Sikorsky Aircraft Corporation

SPECIAL SERVICE INSTRUCTIONS

SSI No. 92-121

Subject: ROTOR DRIVES – Main Gear Box (MGB) Oil Pressure, Temperature, and Pump Warning – Installation of Auxiliary Circuit Breaker Panel and M XMSN PRESS SWITCH Circuit Breaker Modification Kits

CLIPS AND BRACKETS MODIFICATIONS
FIGURE 1 (SHEET 1 OF 2)

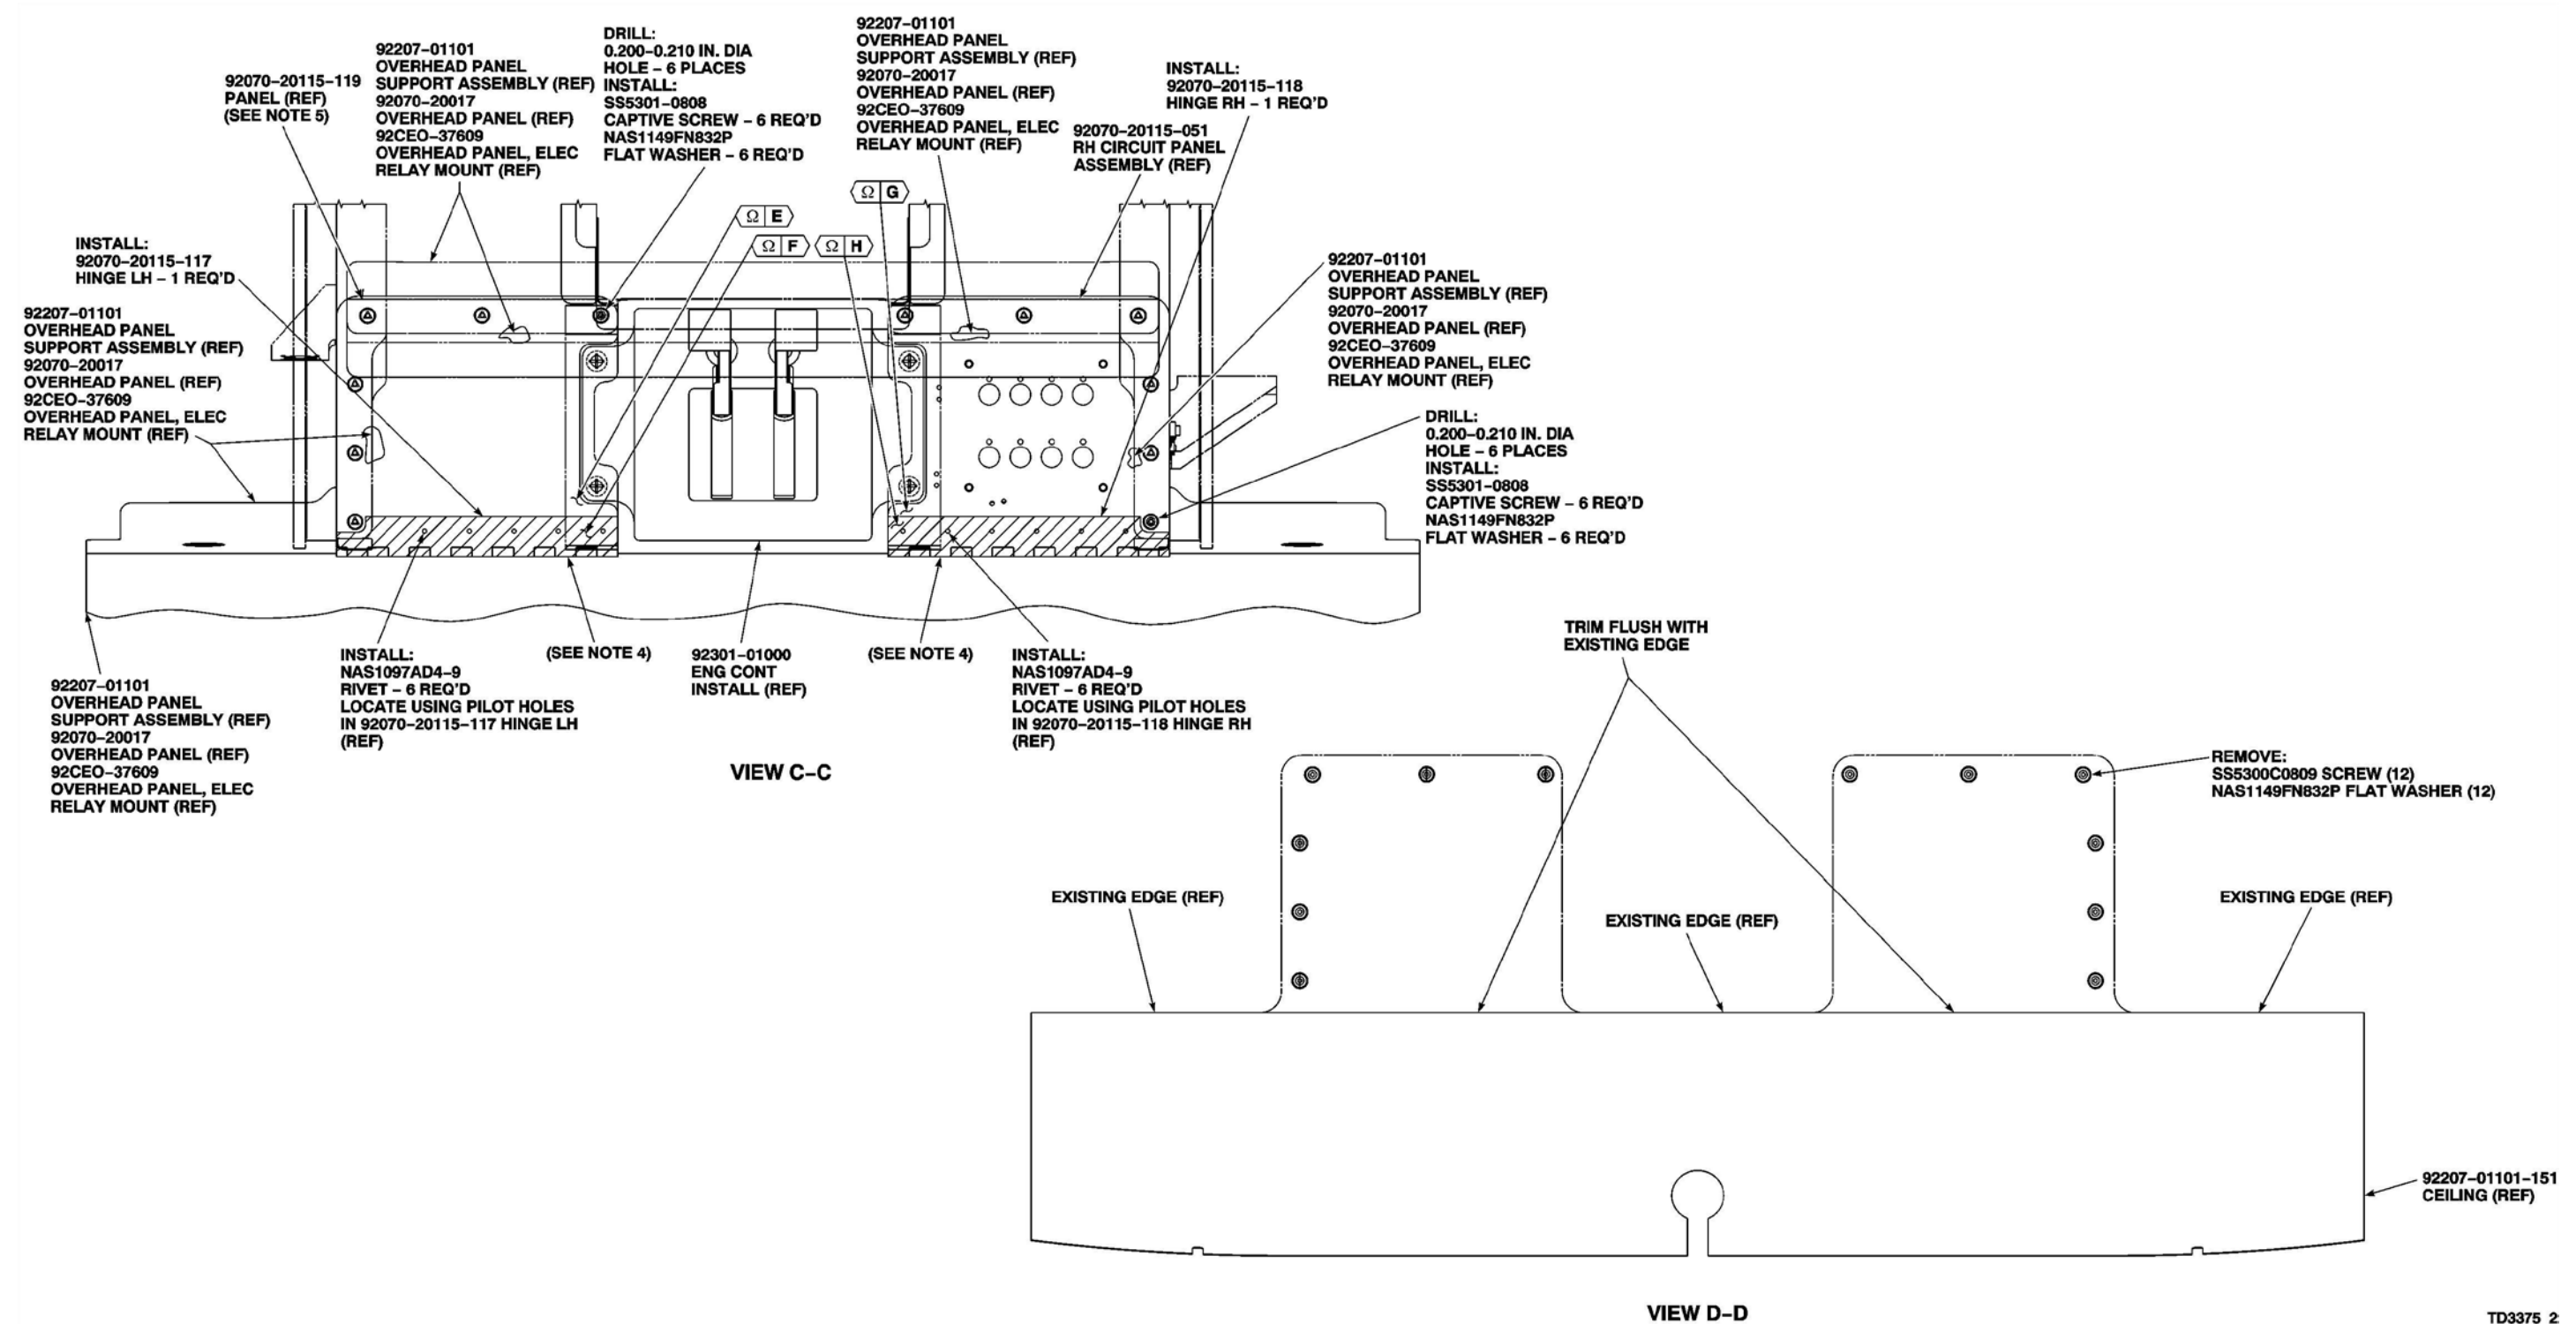
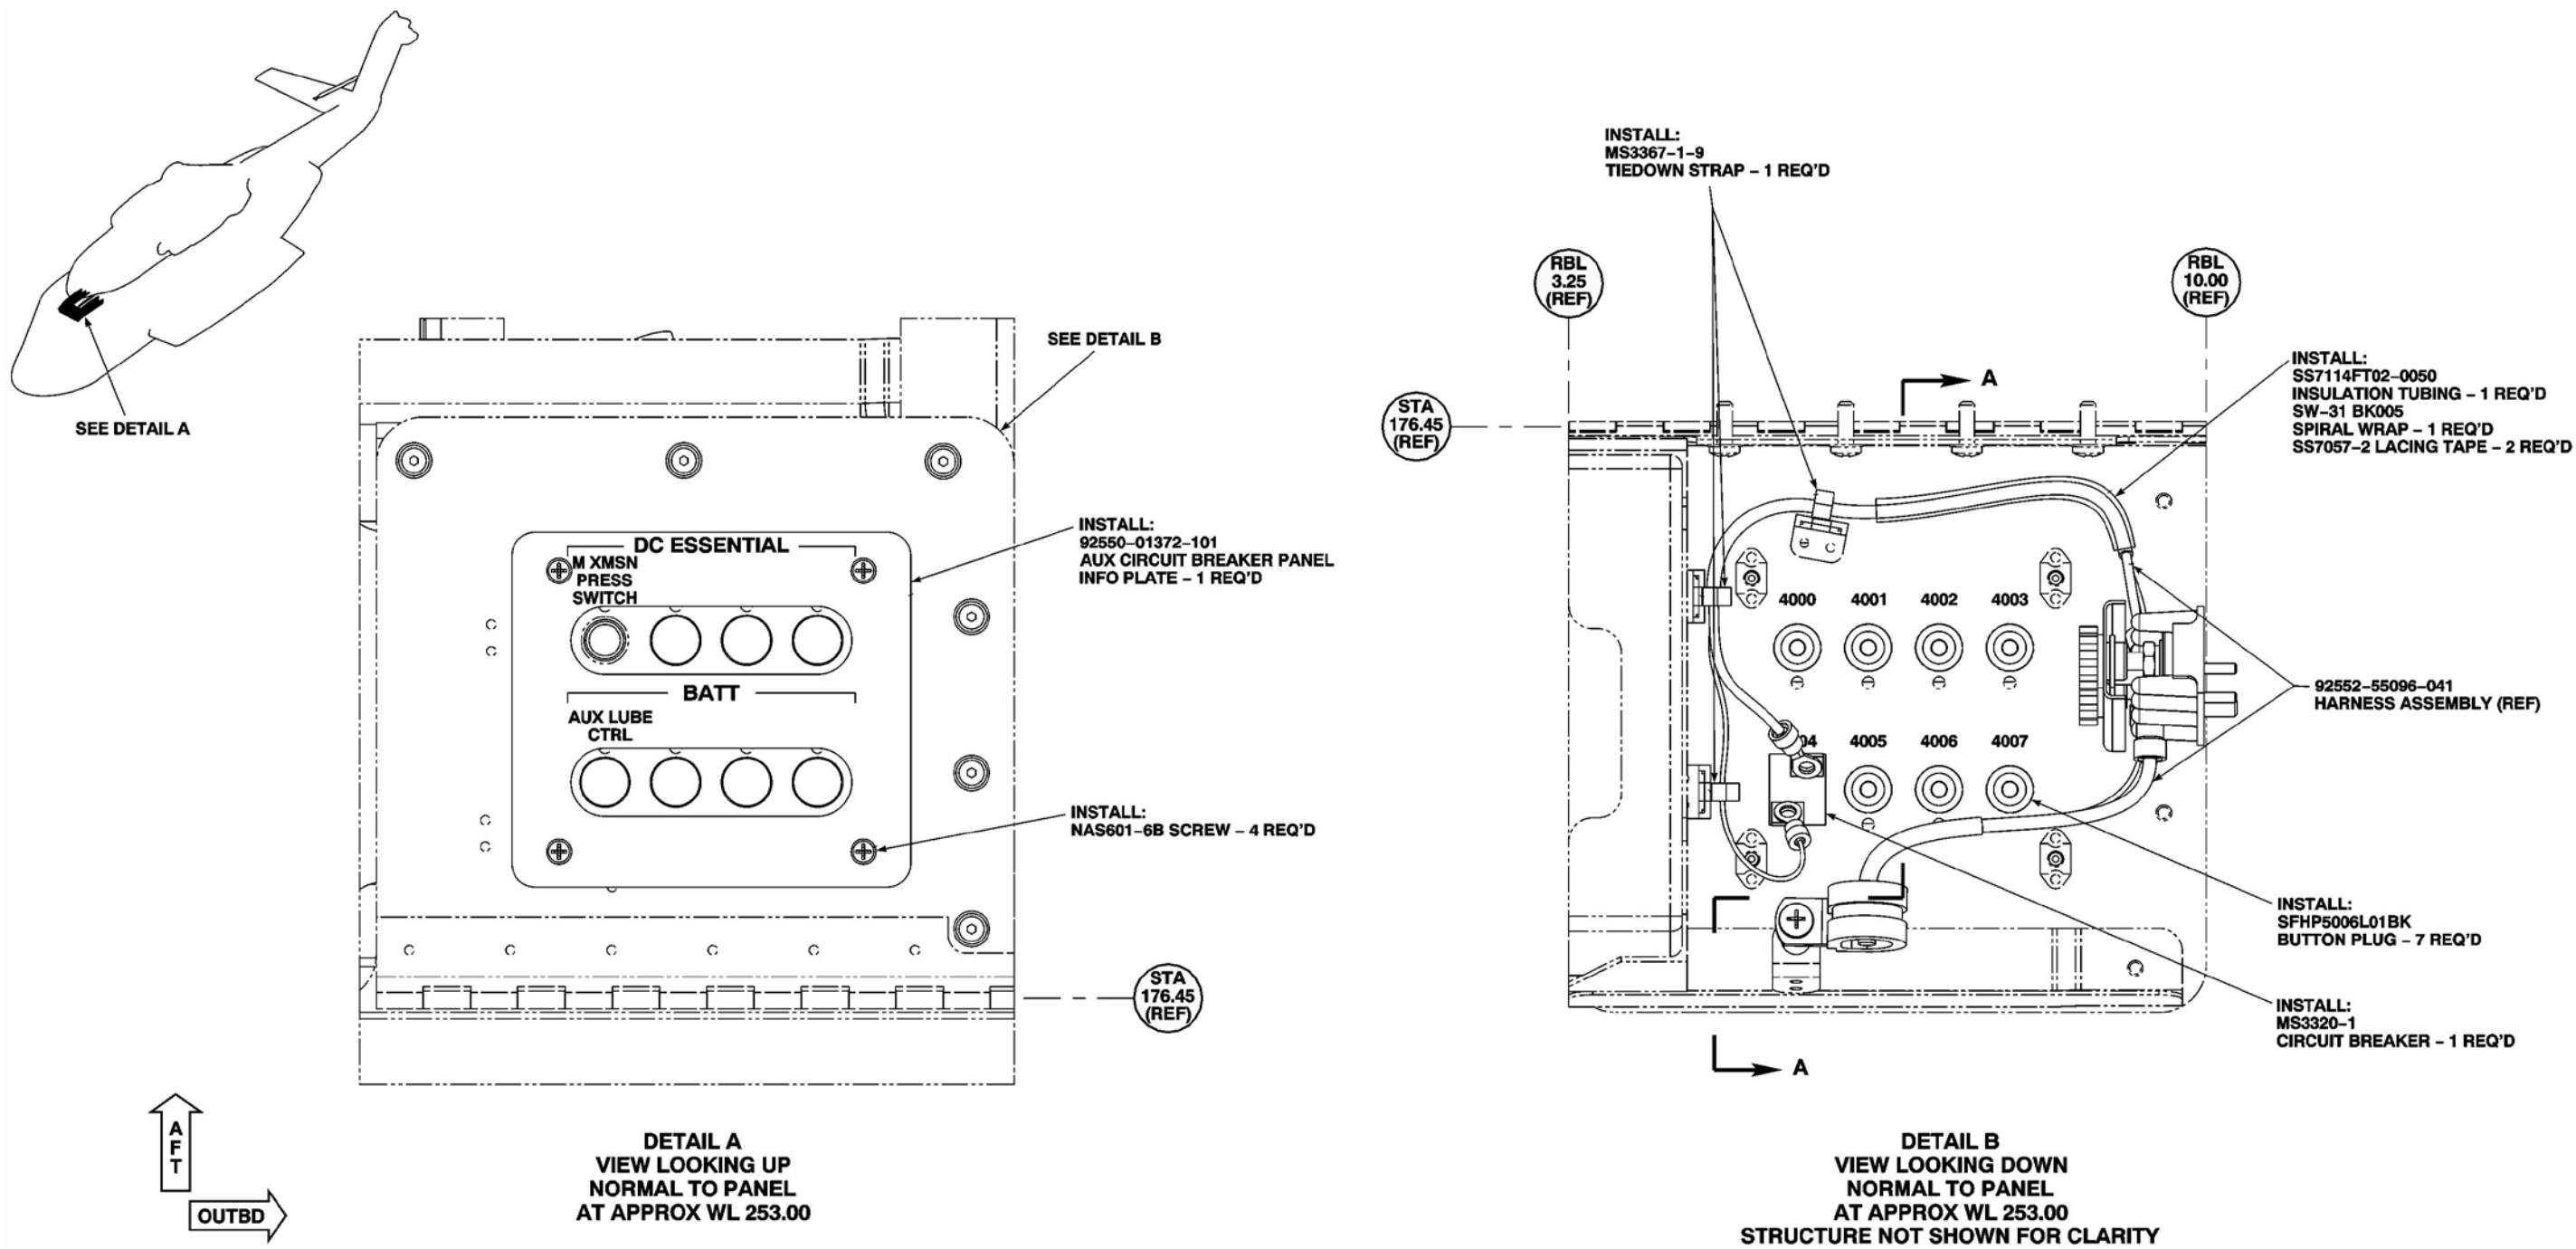
B. Install modification kit clips and brackets installation (M/K CLIPS & BRKTS) (92070-20115-015) as follows (Refer to Figure 1):

- (1) Remove screws (SS5300C0809) and flat washers (NAS1149FN832P) from ceiling (92207-01101-151) (Sheet 2, View D-D).
- (2) Trim ceiling (92207-01101-151) (two places) flush to existing edge.

- (3) Remove rivets (MS20470AD4) from overhead panel support assembly (92207-01101), overhead panel (92070-20017), or overhead panel relay mount (92CEO-37609) (Sheet 1, Section A-A).

- (4) Match drill Right Hand (RH) circuit panel assembly (92070-20115-051) to overhead support installation (92207-01101), overhead panel (92070-20017), or overhead panel relay mount (92CEO-37609) (Sheet 1, Section A-A) (six places). Hole diameters to be 0.200 - 0.210 inch (Sheet 2, View C-C).

- (6) Match drill RH hinge (92070-20115-118) to overhead support installation (92207-01101), overhead panel (92070-20017), or overhead panel relay mount (92CEO-37609) (four places). Hole diameters to be 0.192 - 0.203 inch (Sheet 1, Section B-B).

- (b) Apply chemical conversion coating (MIL-DTL-5541 Class 3 or equivalent) to surfaces that will mate with hinge.
- (c) Install LH hinge (92070-20115-117) on overhead support installation (92207-01101), overhead panel (92070-20017), or overhead panel relay mount (92CEO-37609) with screws (MS27039-0807) and flat washers (NAS1149FN832P).
- (d) Perform electrical bonding check using milliohmmeter (R1L-E2 or equivalent) between points E and F. Resistance shall not exceed 2.5 milliohms (Sheet 2, View C-C).
- (e) Install LH hinge (92070-20115-117) on panel (92070-20115-119) with rivets (NAS1097AD4-9) wet with sealing compound (AMS 3265 or equivalent) (Sheet 2, View C-C).
- (f) Perform electrical bonding check using milliohmmeter (R1L-E2 or equivalent) between points A and B. Resistance shall not exceed 2.5 milliohms (Sheet 1, Section B-B).

- (d) Perform electrical bonding check using milliohmmeter (R1L-E2 or equivalent) between points G and H. Resistance shall not exceed 2.5 milliohms (Sheet 2, View C-C).

- (e) Install RH hinge (92070-20115-118) on RH circuit panel assembly (92070-20115-051) using rivets (NAS1097AD4-9) wet with sealing compound (AMS 3265 or equivalent) (Sheet 2, View C-C).

- (f) Perform electrical bonding check using milliohmmeter (R1L-E2 or equivalent) between points C and D. Resistance shall not exceed 2.5 milliohms (Sheet 1, Section B-B).
